re: Geotechnical Review – Grading and Landscaping Plans
Proposed Residential Development
475 Terry Fox Drive – Ottawa, Ontario

file: PG7418-MEMO.02 Revision 4

Figure 1 – Recommended Lightweight Fill Location Plan

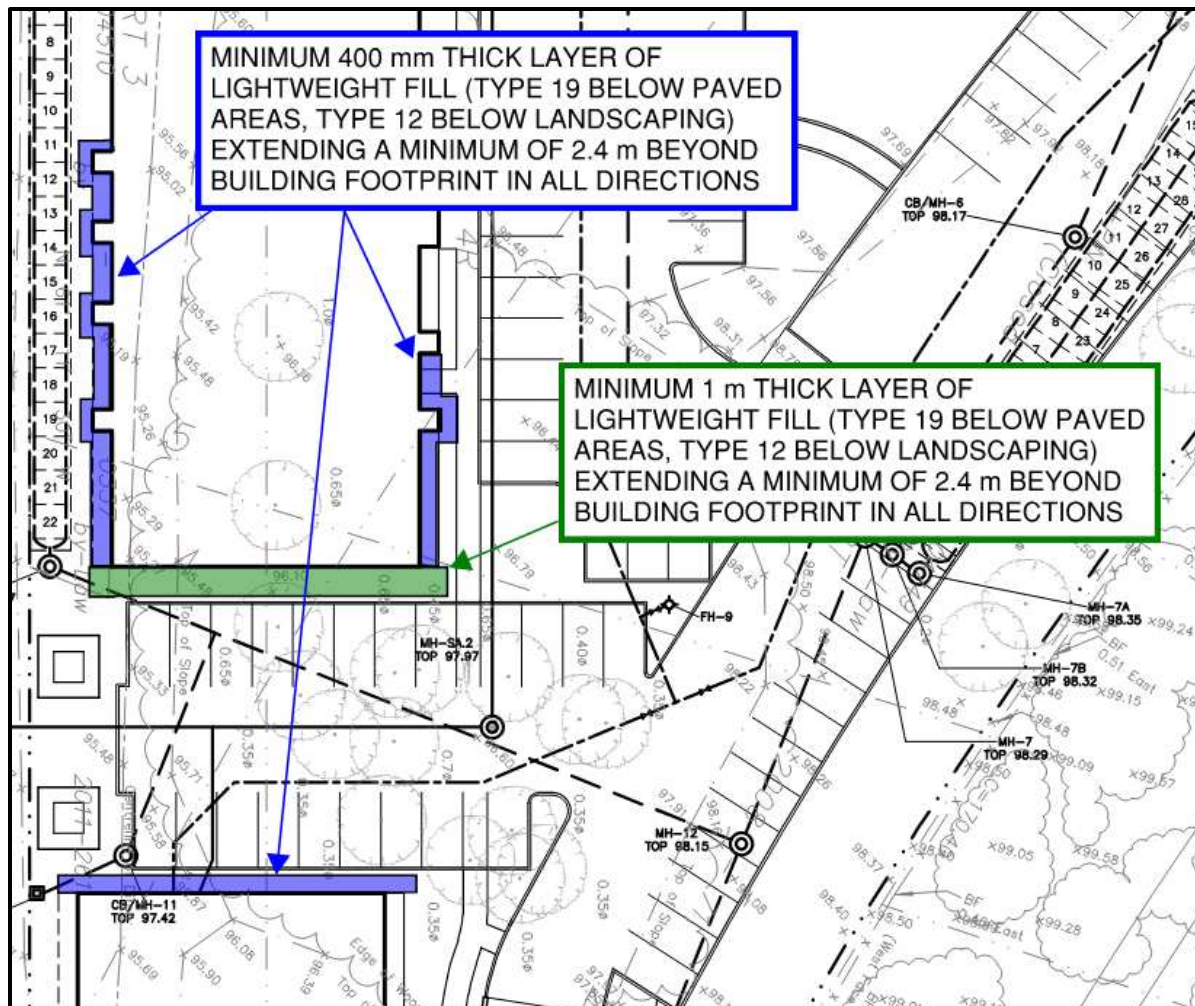
However, some grade raise exceedances were identified in areas surrounding the proposed Building B and Building C. For these areas, lightweight fill is recommended to be placed per the locations identified in Figure 1 below to accommodate the grade raise restriction exceedances and mitigate long-term settlements.

It should be noted that additional exceedances were identified along the eastern portion of Building B. However, based on our review, these exceedances are considered minor and tolerable from a geotechnical perspective such that lightweight fill is not considered required to accommodate those exceedances at this time.

Provided the proposed grading is accommodated using lightweight fill as described in this memorandum, the proposed grading for the proposed development is considered acceptable from a geotechnical perspective.

Lightweight fill (LWF) should consist of EPS (expanded polystyrene) Type 19 and Type 12 geofoam blocks throughout hardscaped (paved or other areas with concrete surface features) and landscaped areas, respectively. The LWF is recommended to be placed a minimum of 500 mm above any perimeter drainage sleeves/pipes provided to the main building structures foundation and the associated open-graded stone layers. The lightweight fill should be placed upon a flat soil surface. Therefore, the soil should be compacted to be relatively smooth and flat prior to installation. Consideration may be given to placing a thin layer of sand or stone dust to attain a relatively smooth/flat surface for placement.

The entire lightweight fill layer footprint is recommended to be covered with a layer of polyethylene (taped at seams) extending between the building footprint and outer edge of the layer and extending below its surface by a minimum of 100 mm at all edges of the lightweight fill layer.

If the lightweight fill will be located in an area of landscaping, a minimum 600 mm of soil cover is recommended to be provided to the lightweight fill layer to promote grass and associated vegetation to establish overtop the lightweight fill. The placement of all lightweight fill should be reviewed at the time of placement by Paterson personnel. It is advised that a brief pre-construction meeting be held between Paterson and the construction team to confirm placement methodology prior to the installation.
